GTS2, Hull

Type 3 Fire Risk Assessment

Prepared for:	Rebecca Franks, Building Safety Manager
Prepared by:	John Askew, Fire Risk Assessor, Holistic Fire Safety
Date Submitted:	26/11/2025
Document Reference:	HFS.HCC.GTS2.FRA.2.0

Photo 50

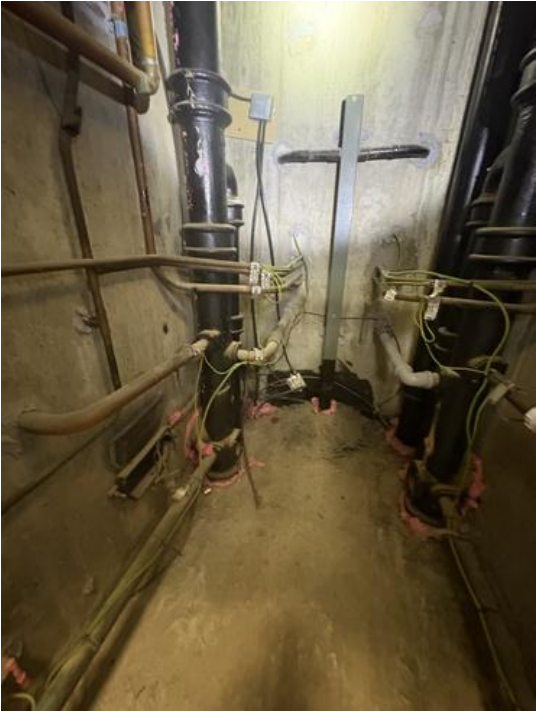
The glazing between the laundry and caretakers office is not suspected to be fire resisting. A fire in the laundry would affect the caretakers office and vice versa therefore, the glass requires replacing with fire rated glass alternatively, install gypsum-based plasterboard or cement board to compartment area.

Replace glazing with fire rated glass alternatively, install gypsum-based plasterboard or cement board.

Photo 112

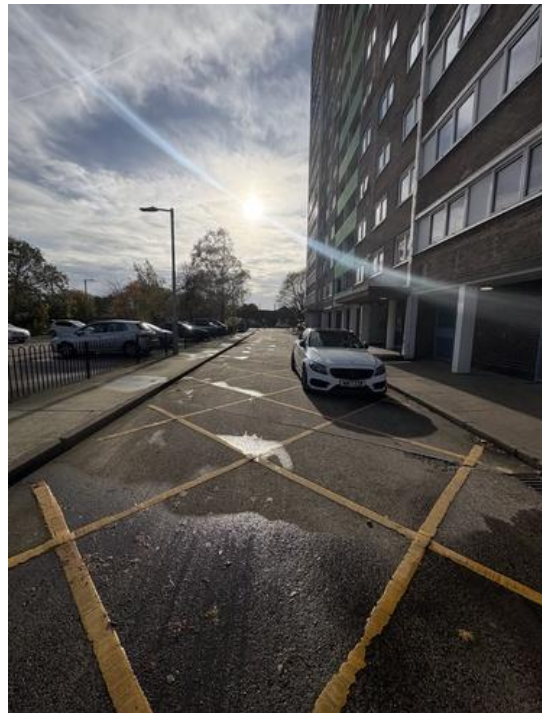
Fire extinguishers were installed in 2024 and therefore due for their annual inspection soon. Consideration should be given to the provision of training and who this task of inspection will be allocated to.

Consideration should be given to the provision of training and who this task of inspection will be allocated to.
